**Tri Tac public comments**

RE: Loop Road North Parking Lot Project, Kirkwood

### Loop Road North Parking Area Kirkwood, California

**To:** Chuck Beatty, Amador County  
**From:** Andi Panagopoulos, Cunningham Engineering Corporation (CEC)  
**cc:** Nate Whaley, Village East, LLC  
**Date:** December 9, 2014  
**Subject:** Response to County Comments received via email November 19, 2014 regarding The Loop Road North Parking Area, Kirkwood

**EXHIBIT  
 KIRKWOOD - PARKING LOT EXPANSION**

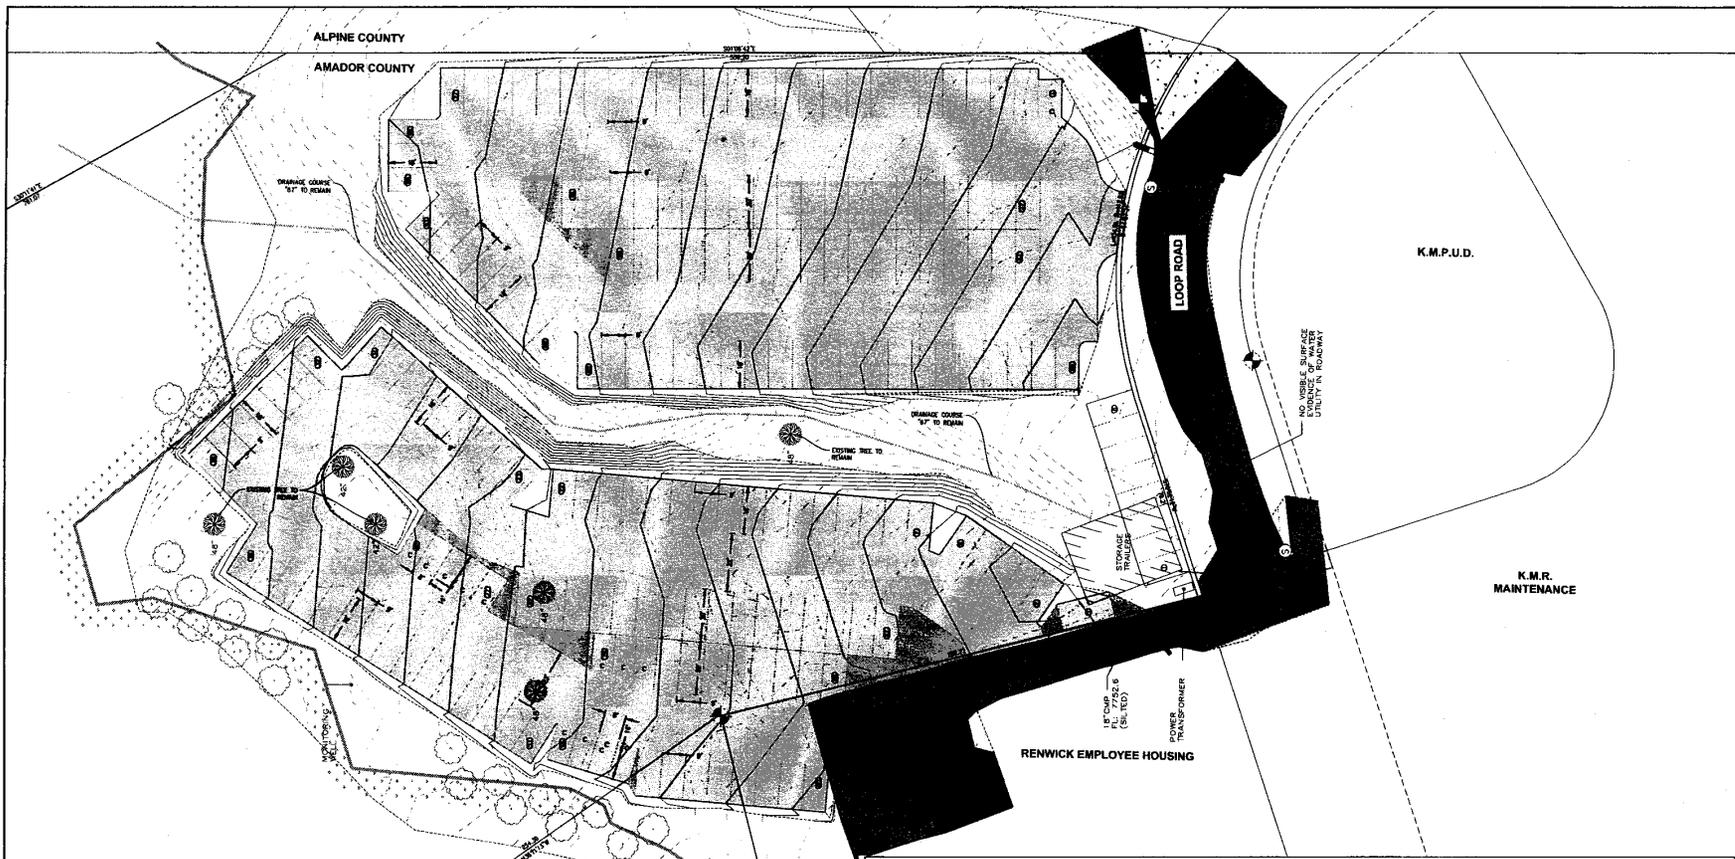
3. The portion of the lot shown in red on the Assessor's Map is only about 1.3 acres, so I'm guessing the 2-acre area to be rezoned is shown inside the dashed line on the site plan. If so, the rezone area encroaches into the employee housing lot (026-270-031), and doesn't have any specific boundary description. We'll need that description in meets & bounds so that we know exactly what property gets rezoned. *Please refer to the revised Plot Plan Exhibit and the Rezone Exhibit for the delineation between the total project area boundary and the rezone area boundary. We also included a legal description of the rezone area as requested.*

4. The plans show 189 parking spaces versus the 216 in the narrative. *The parking layout is currently in the conceptual design phase and at this time it is anticipated to include approximately 193 parking spaces. The number of parking spaces will be established as the project proceeds through the design process.*

| <p><b>PLOT PLAN EXHIBIT</b></p> <p><b>KIRKWOOD - LOOP ROAD NORTH PARKING AREA</b></p>                |  | <p>DATE: 04/07/15</p> <p>BY: [Signature]</p>                                                 |

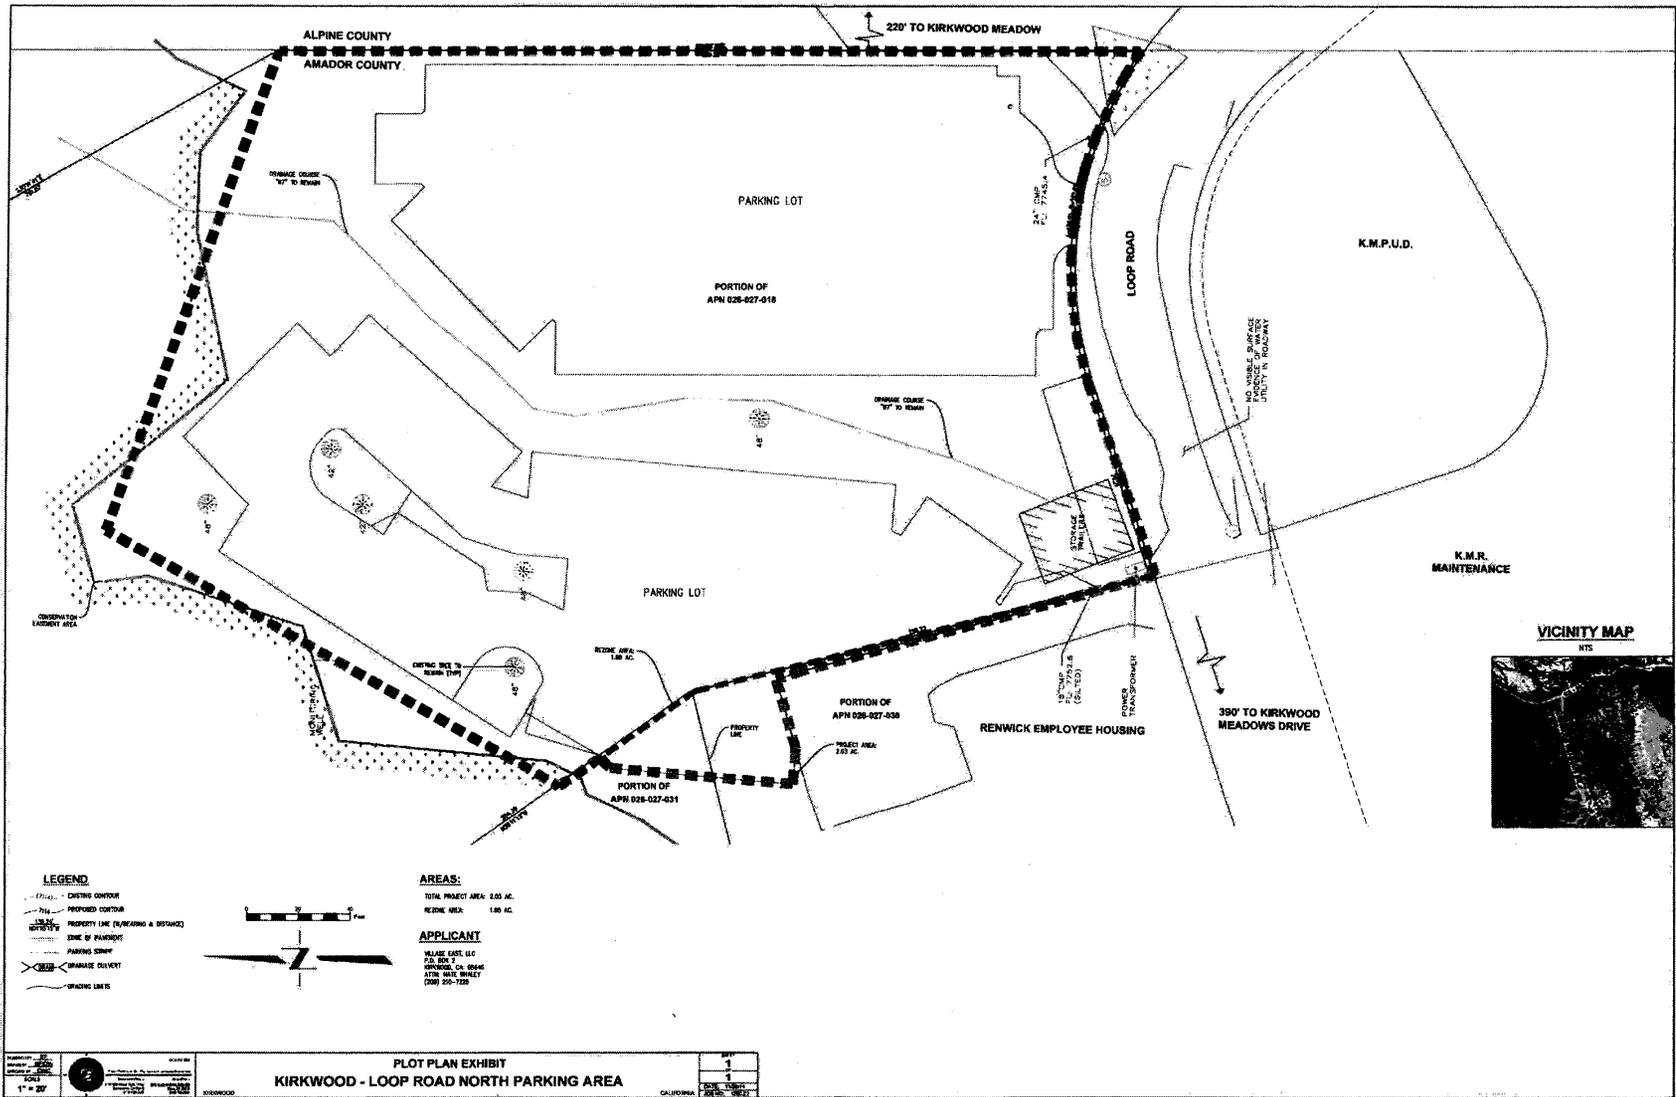
5. Two trees proposed for retention in the west lot are marked 42" dbh. The plan shows very little space being reserved for the tree roots, with encroachment within six feet of the trunks. One doesn't require a chainsaw to kill a tree; destroying the rooting area is also effective. Most governing bodies realize that trees need healthy root systems and try to ensure this by requiring that the rooting zone beneath the canopy is protected from construction activities, such as compaction, grade cuts or fills, trenching, and paving. This is known as the Tree Protection Zone and is often defined as a circle whose radius is scribed by the length of the longest limb. Kirkwood Specific Plan 7.1.1 calls for tree root protection by ensuring adequate setbacks during construction, but does not define "adequate." My opinion is that too much encroachment of the remaining trees by proposed fill and paving will terminally affect them.

6. The 2003 Kirkwood Specific Plan Section 7.2.2 refers to wetland and riparian protections. I note that the stream that bounds the northern side of the proposal is not located on the site map, making comments about impacts difficult. However, photograph 7 shows some newly placed red survey stakes near and in the creek bed that seem to approximate locations of proposed screening trees as shown on the project map.
